The Town of Hilton Head Island Regular Design Review Board Meeting

AGENDA

DESIGN TEAM/ DRB COMMENT SHEET

DESIGN TEAM/ DRB COMMENT SHEET

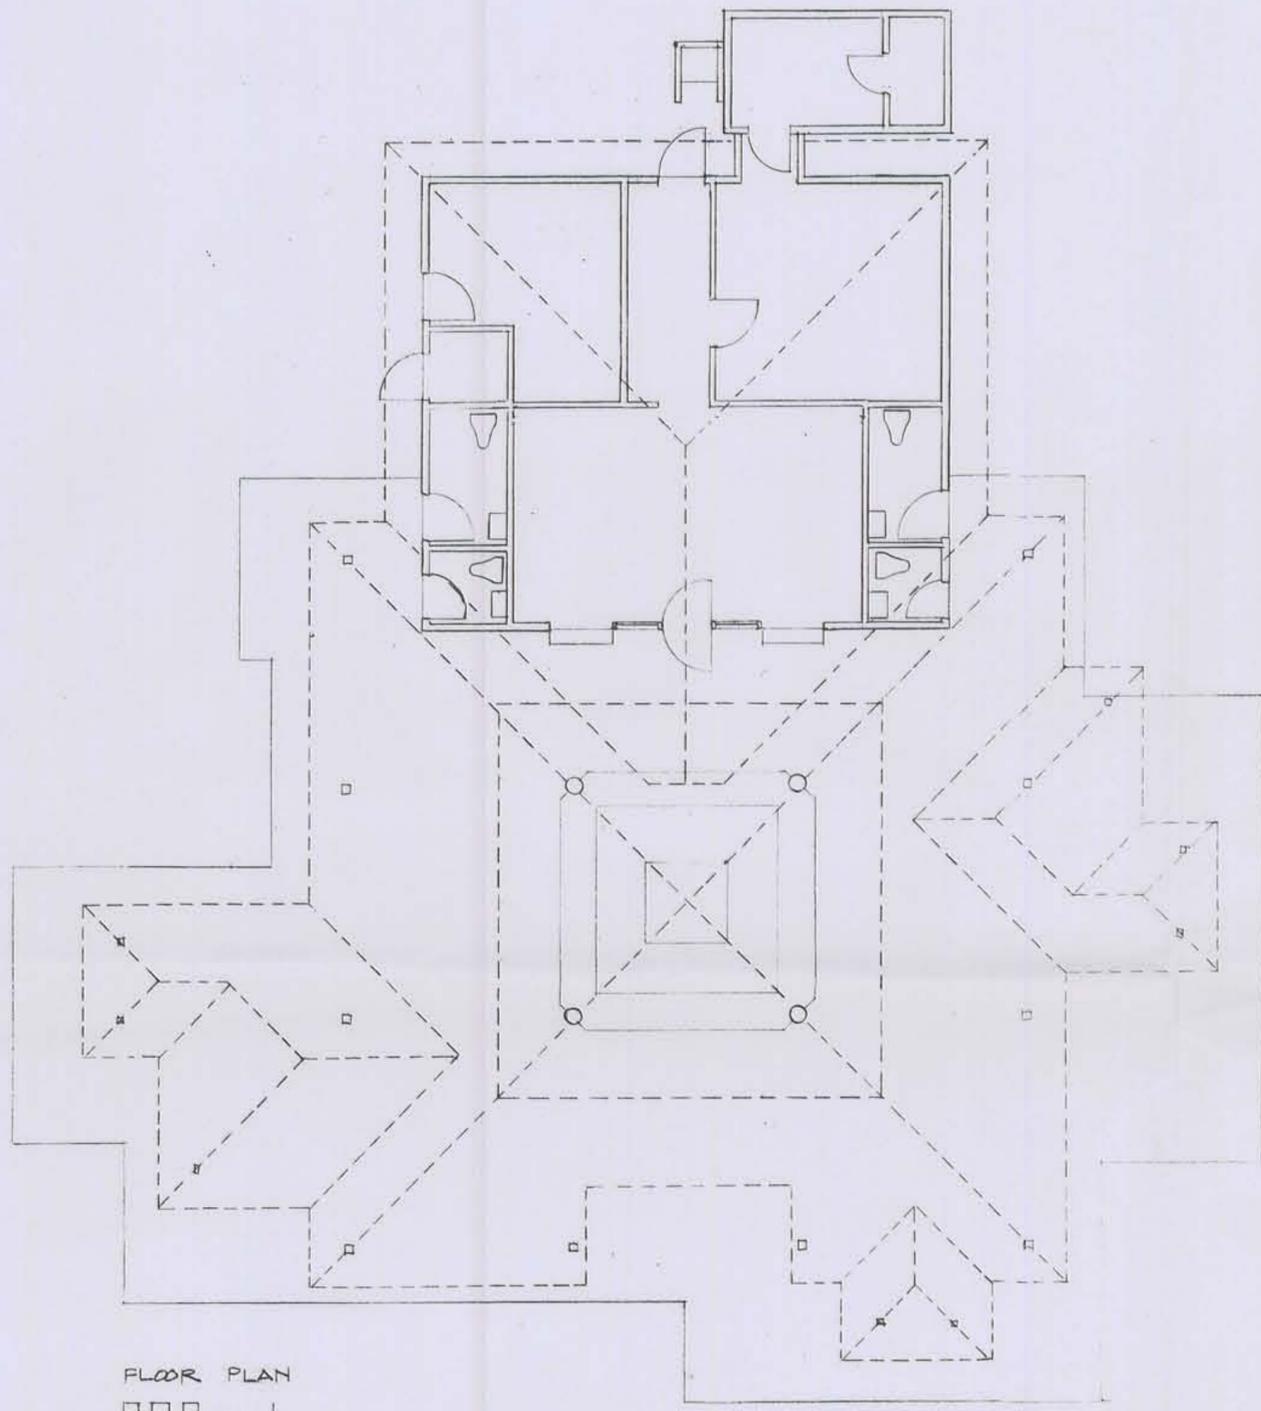
Placement of the structure relative to the specimen oak shown on the site analysis will be critical for approval, relative to DRB and Development Plan Review approval. As shown, the structure would need to be moved.

DESIGN GUIDE/LMO CRITERIA	COMPLIES YES/NO/NA	COMMENTS OR CONDITIONS
An effort has been made to preserve existing trees and under story plants	No	The unlabeled “dot” at the left rear of the proposed building is a specimen 58 inch live oak. Under the Land Management Ordinance, specimen trees are given special protection; the plan as submitted would destroy the root system of the tree, and therefore would not be approvable by Natural Resources.
Supplemental and replacement trees meet

FLOOR PLAN

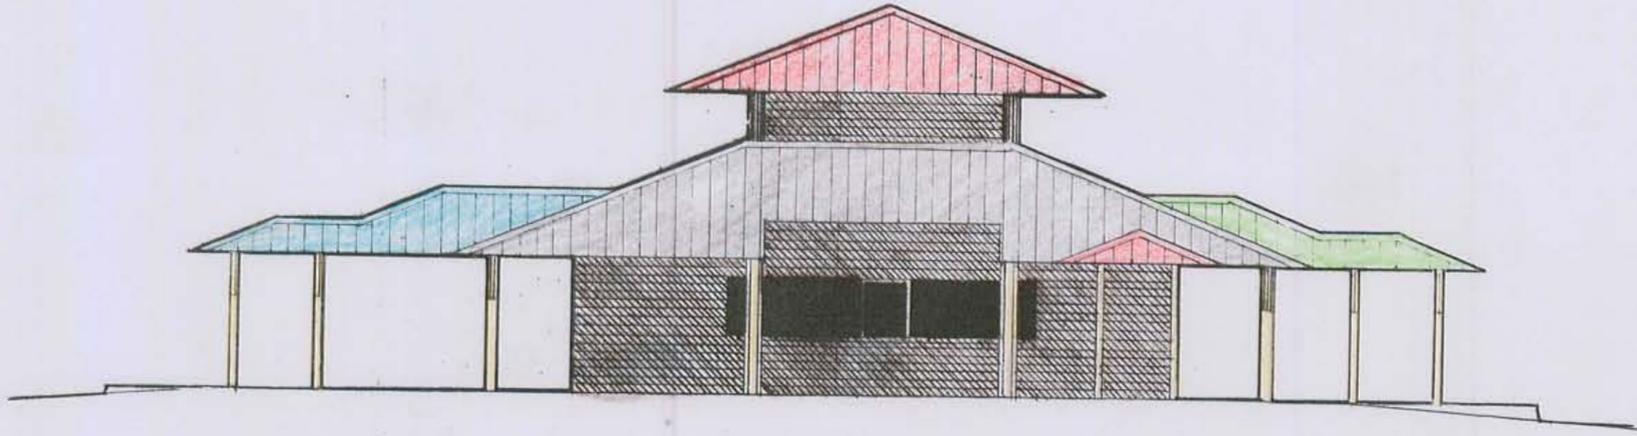
An ADA compliant seat will be required at the bar with a counter height of 36” above FFE

The floor plans do not designate any equipment inside the building. A hood system may be required and the hood vent is not shown on the elevations.

1 BARONY BEACH CLUB BAR & GRILL: ELEVATION
SCALE 1/4"=1'-0"

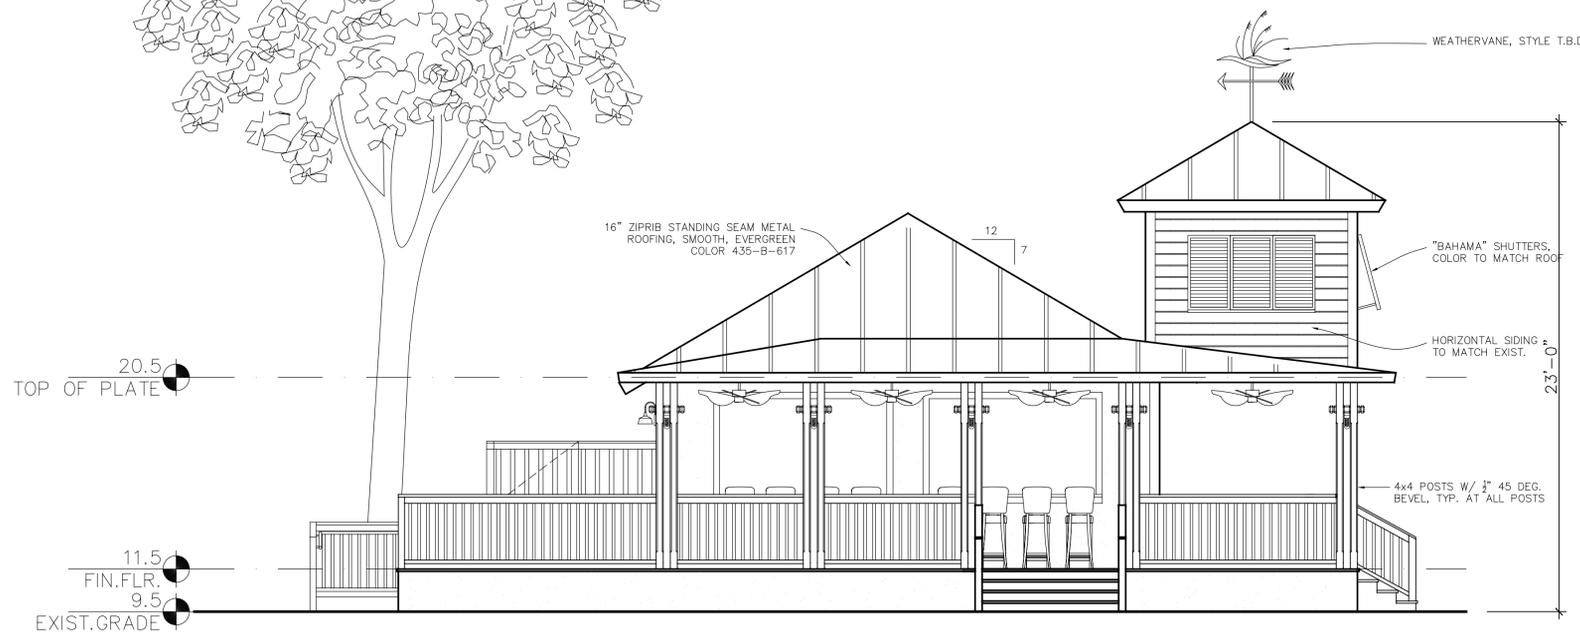
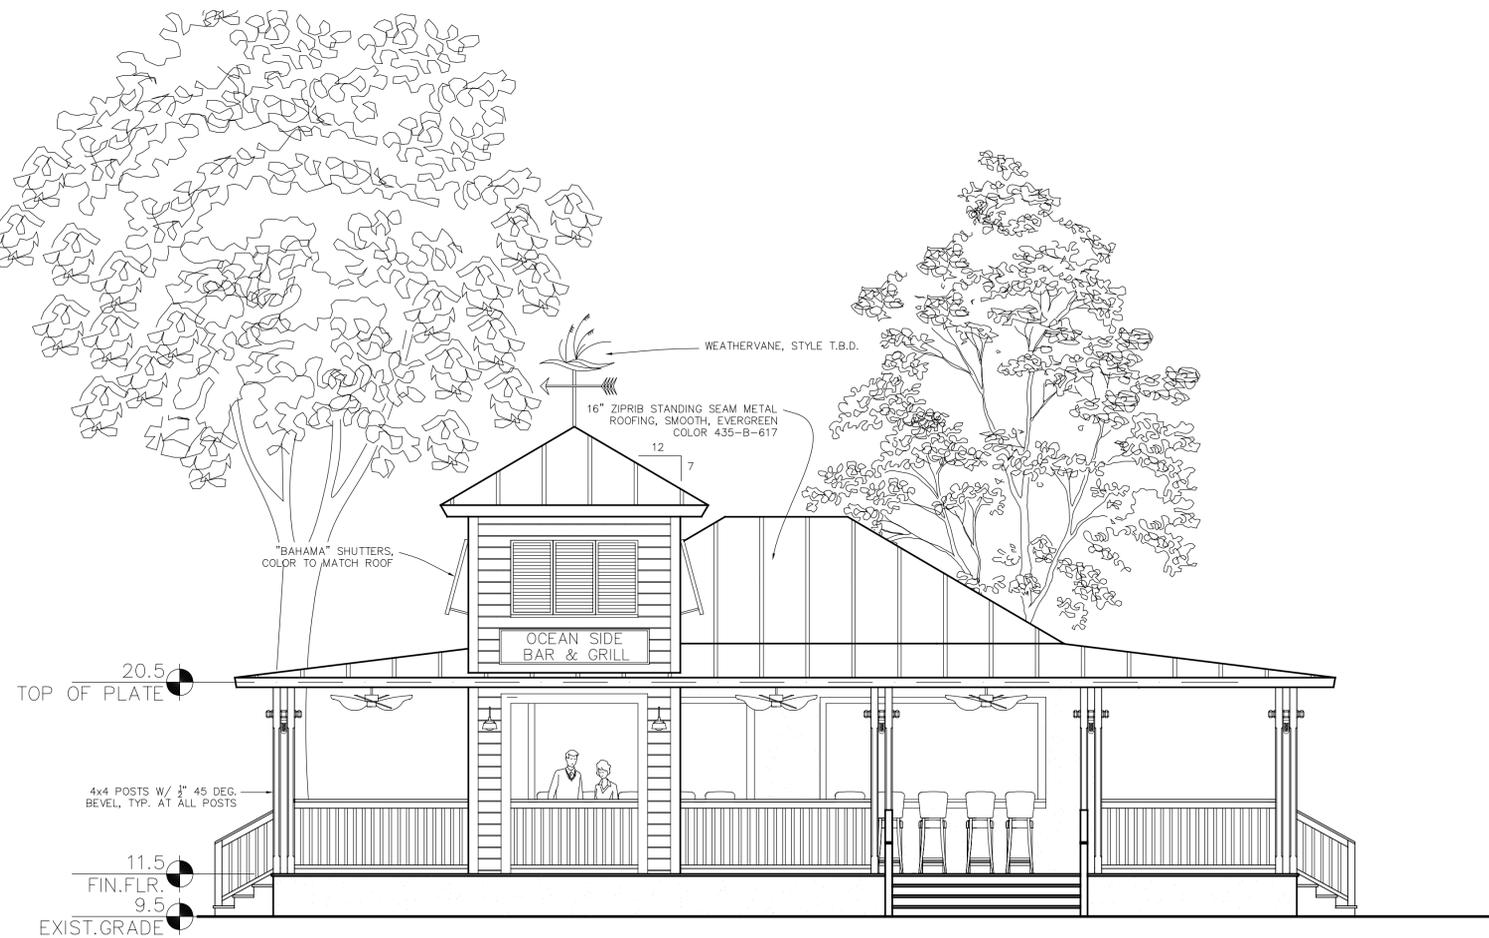
Bar must have one ADA accessible seating area with a bar height of 36" above FFE. Some consideration will need to be taken to fulfill this and the 15' msl floodproofing requirement.

Hood element(s) not shown on drawings.

ELEVATIONS
 Drawing title
A3.1
 Drawing number
 50
 sequence number
 136

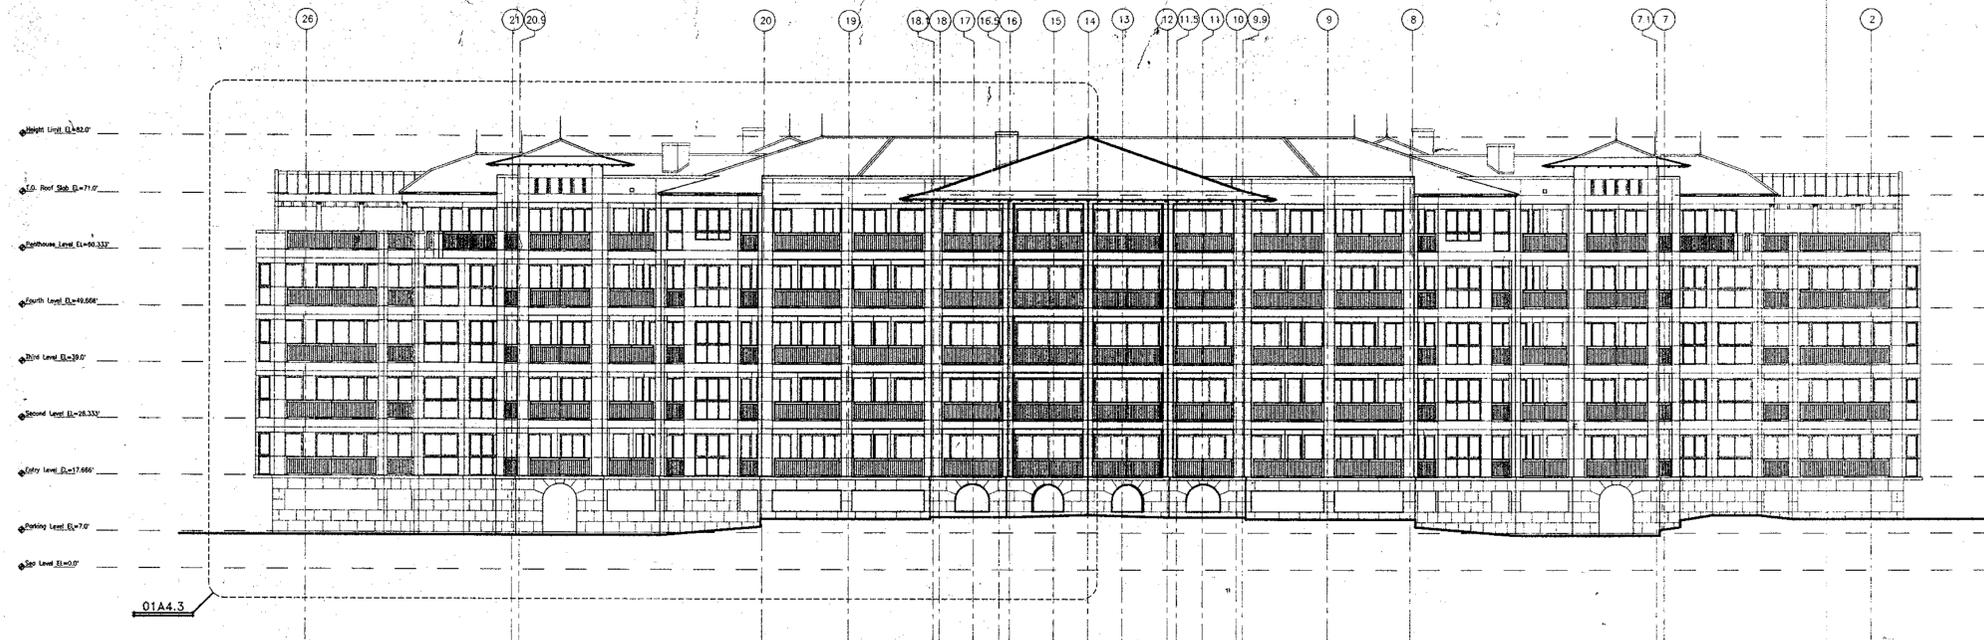
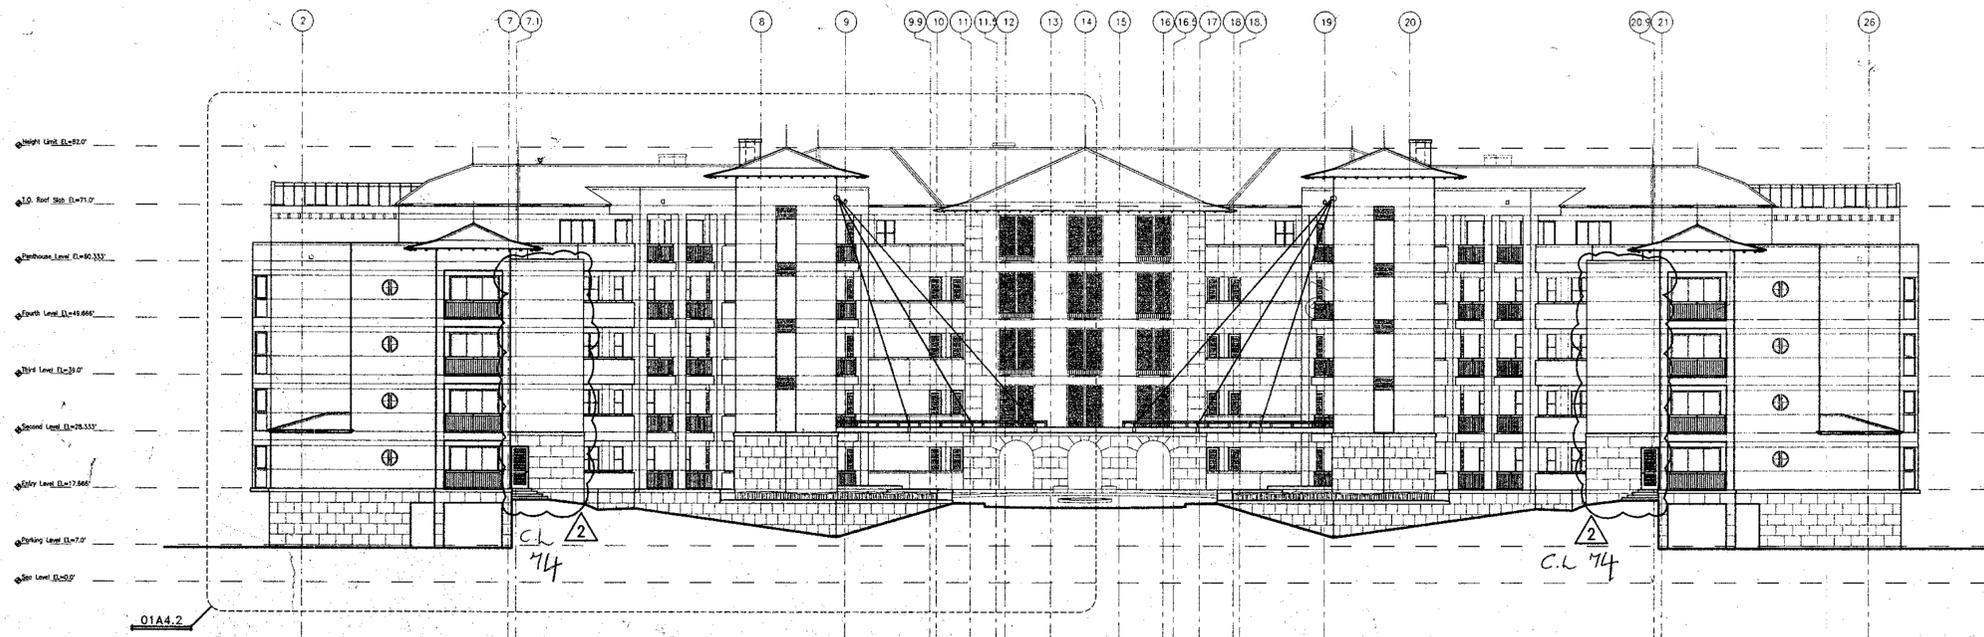
ARCHITECTURAL DESIGN		
Applicant wishes to replace shingle replication with standing seam metal roof. Three colors have been provided (grey, blue, brown/red) with grey being the preferred alternative. Actual color samples will be provided at the meeting. Staff recommends approval of the applicant's preferred grey.		
DESIGN GUIDE/LMO CRITERIA	COMPLIES YES/NO/N/A	COMMENTS OR CONDITIONS
Structure is designed to be appropriate to the neighborhood		
Promotes pedestrian scale and circulation		
Design is unobtrusive and set into the natural environment		
Utilizes natural materials and colors		
Avoids distinctive vernacular styles		
Design is appropriate for its use		
All facades are have equal design characteristics		
Avoids monotonous planes or unrelieved repetition		
Has a strong roof form with enough variety to provide visual interest		
Minimum roof pitch of 6/12		
Overhangs are sufficient for the façade height.
